**INSTITUTE FOR RESOURCE AND SECURITY STUDIES
27 Ellsworth Avenue, Cambridge, Massachusetts 02139, USA**

Declaration of 19 December 2013
by Gordon R. Thompson:

Comments on the US Nuclear Regulatory Commission's
Waste Confidence Generic Environmental Impact Statement,
Draft Report for Comment (September 2013)

Figure V-1
Core Damage Frequency for Accidents at a Surry PWR Nuclear Power Plant, as
Estimated in the NRC Study NUREG-1150

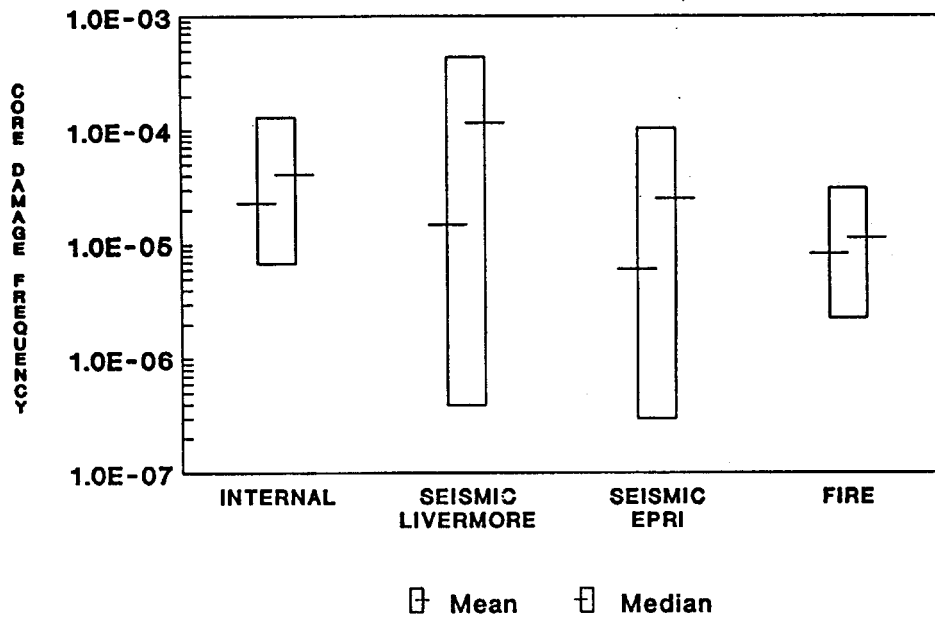
(V-5) Figures V-1 through V-3 show PRA findings for two commercial reactors – a pressurized-water reactor (PWR) at the Surry site, and a boiling-water reactor (BWR) at the Peach Bottom site. Figures V-1 and V-2 show the estimated probability of an accident involving substantial damage to the reactor core. Such damage would involve melting of some or all of the fuel in the core. The probability is expressed as core damage frequency (CDF) per reactor-year (RY). Figure V-3 shows the estimated conditional probability (i.e., probability given core damage) of various types of containment failure. A failure of containment would lead to a release of radioactive material to the atmosphere. The earlier the failure, the larger the release, other factors being equal.

Figure V-3
Conditional Probability of Containment Failure Following a Core-Damage Accident
at a Surry PWR or Peach Bottom BWR Nuclear Power Plant, as Estimated in the
NRC Study NUREG-1150

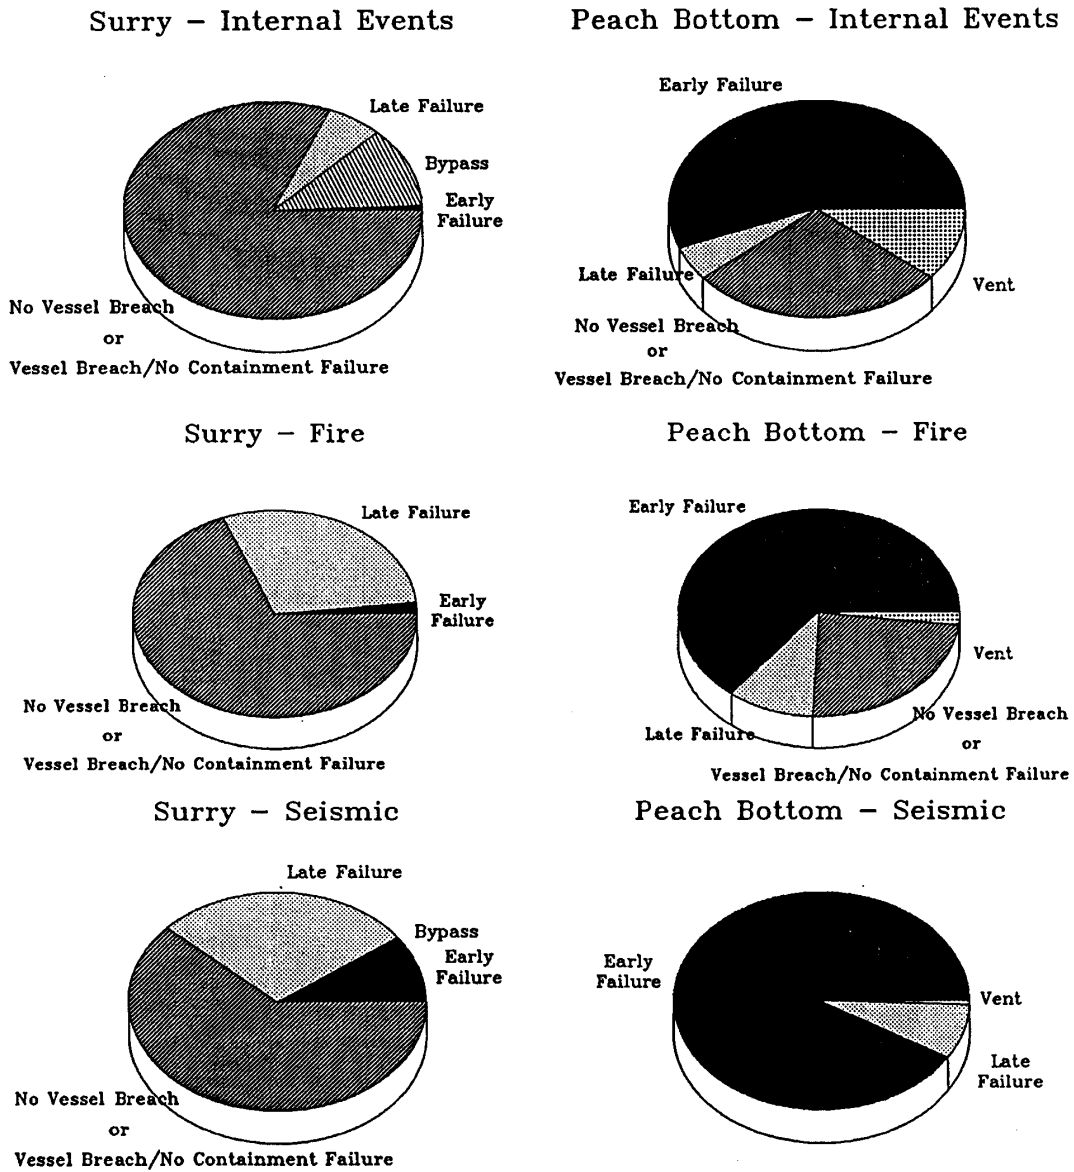
(V-25) Estimating the probability of core damage is just one step in assessing the radiological risk posed by a commercial reactor. Another step is to estimate the potential release of radioactive material to the environment. Figure V-3 illustrates a part of that step – estimating the conditional probability of failure of containment, given core damage. Additional steps include estimation of the movement of radioactive material in the environment, and estimation of the resulting consequences. As mentioned above, assessment of radiological risk involves the compiling of a set of qualitative and quantitative information about both probability and consequences.

Figure V-4
Contamination of Land in Japan by Radioactive Cesium Released to Atmosphere
During the Fukushima #1 Accident of 2011

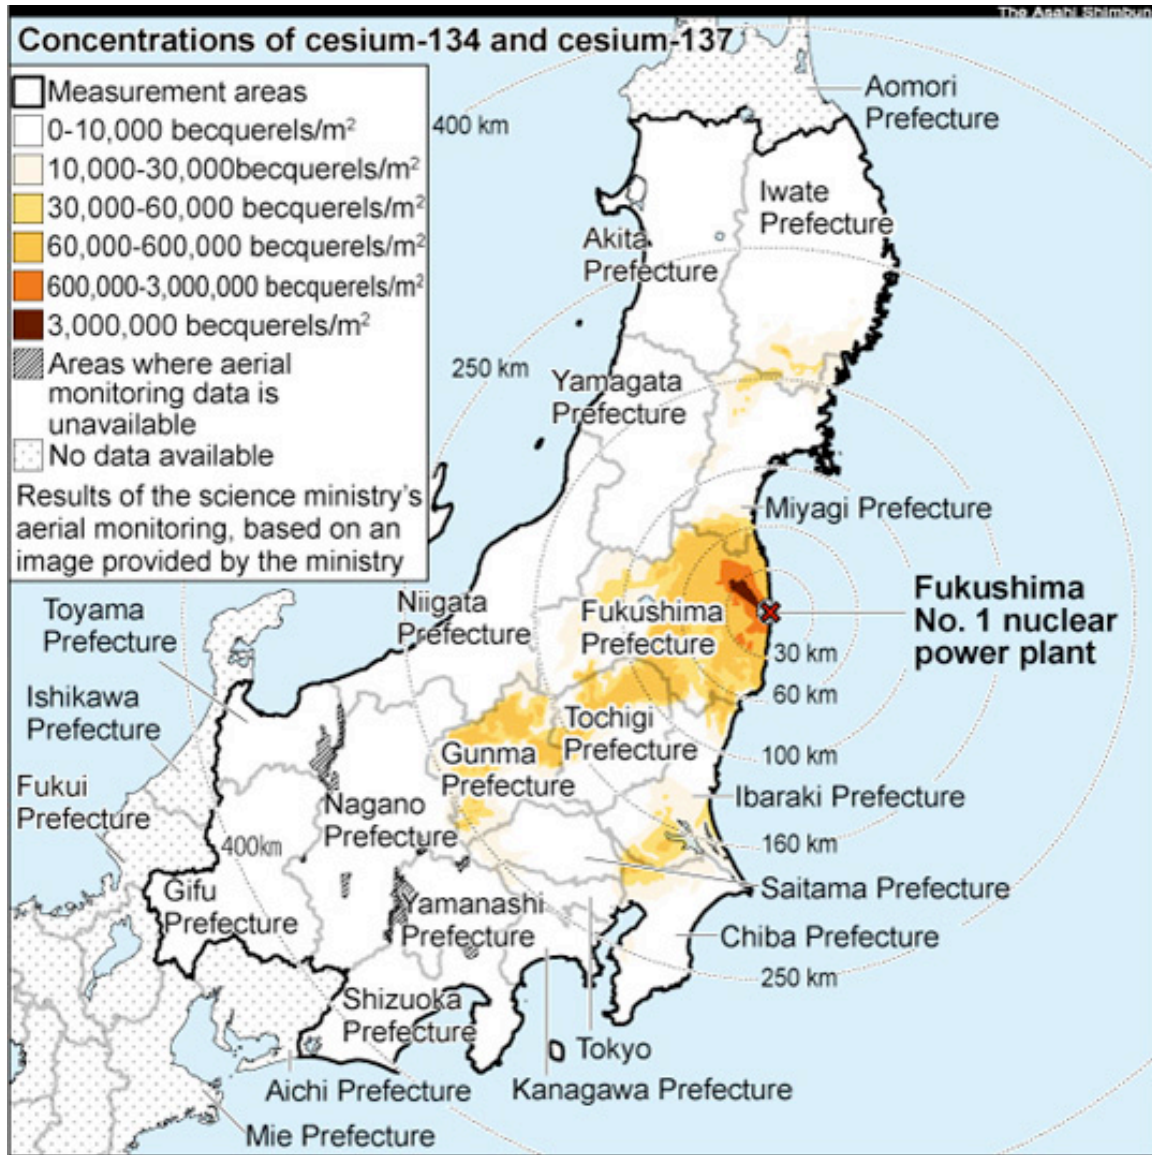
(X-50) Japan’s experience with fallout from the 2011 Fukushima accident is instructive. The pattern of radioactive fallout across Japan is complex, as shown in Figure V-4. That fallout contained about 6 PBq of Cs-137, as shown in Table V-1. This amount of Cs-137 is comparatively small in the context of a potential release from a pool fire. Yet, the impacts of the Fukushima fallout on Japan are diverse and significant. For example, it is reported that 160,000 people were displaced from land contaminated by the Fukushima accident, and about one-third of this population remains in temporary housing. There is considerable uncertainty about the number of people who may be able to return to their homes.¹³³ Also, all of Japan’s nuclear power plants remain shut down, due to public concern about their operation.

**Figure VIII-2
Schematic View of a BWR Reactor with a Mark I Containment, as Used at the
Fukushima #1 Site and Elsewhere**

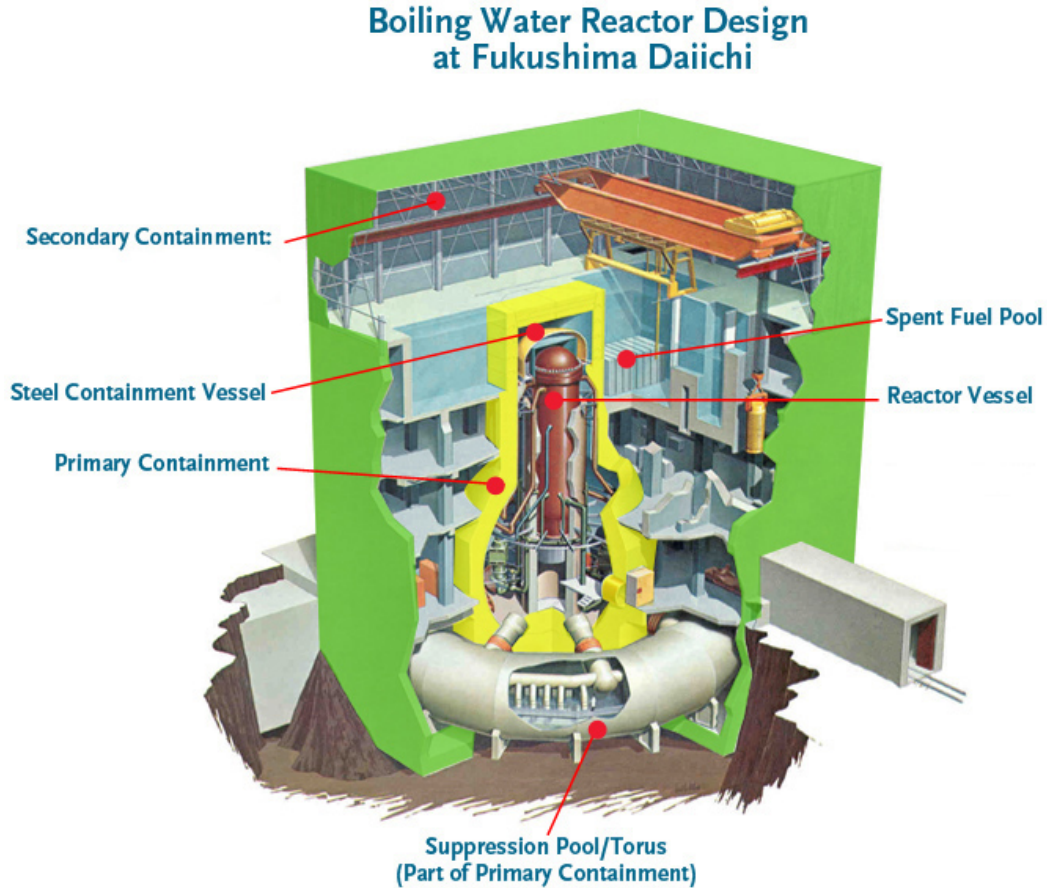
(VIII-18) Figure VIII-2 illustrates how intimately a spent-fuel pool can be associated with the reactor it serves. Moreover – as discussed in paragraph VIII-6, above – at 17 sites in the United States, any fuel in a pool is intimately associated with two adjacent reactors. In other instances, the association between a pool and a different, nearby reactor may not be quite so intimate. Nevertheless, physical proximity, sharing of buildings, and/or sharing of support systems could establish a strong linkage of pool risk and reactor risk. One concern is that a release of radioactive material from a reactor could create a radiation field that precludes personnel access needed to keep a nearby spent-fuel pool in a safe state. Lack of that access could lead to a pool fire.

Figure X-1
PWR Spent Fuel Storage Racks: Low-Density and High-Density Designs

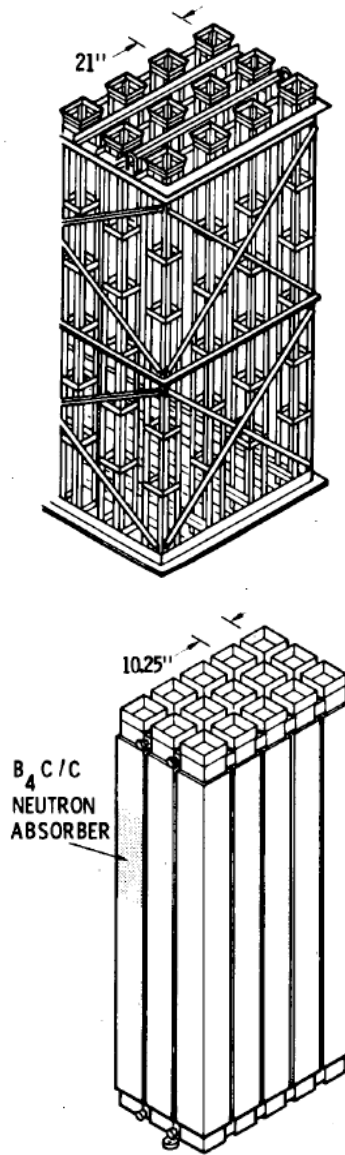
(X-8) As discussed in paragraph I-7, above, the pool serving each commercial reactor in the USA is now equipped with high-density, closed-frame racks. The nuclear industry began installing these racks in the 1970s, to replace the low-density, open-frame racks previously used. The high-density racks offered a comparatively cheap option for storing a growing nationwide inventory of spent fuel. Figure X-1 shows the configurations of the two types of rack.

(X-9) If water were lost from a pool equipped with high-density racks, the racks would inhibit heat transfer from the exposed fuel. Thus, spent fuel in the pool would increase in temperature, potentially leading to ignition and sustained combustion of zircaloy cladding in air or steam. To a technically trained observer, it should be obvious that ignition could be more likely if residual water were present in the pool, other factors being equal. Residual water would block the flow of air from below, thus reducing heat transfer from the exposed portion of the fuel. Figure X-2 illustrates this phenomenon. As a result, spent fuel with a comparatively high age after discharge from a reactor could burn if residual water were present. The initial phase of "burning" would, in this case, be a steam-zircaloy reaction.
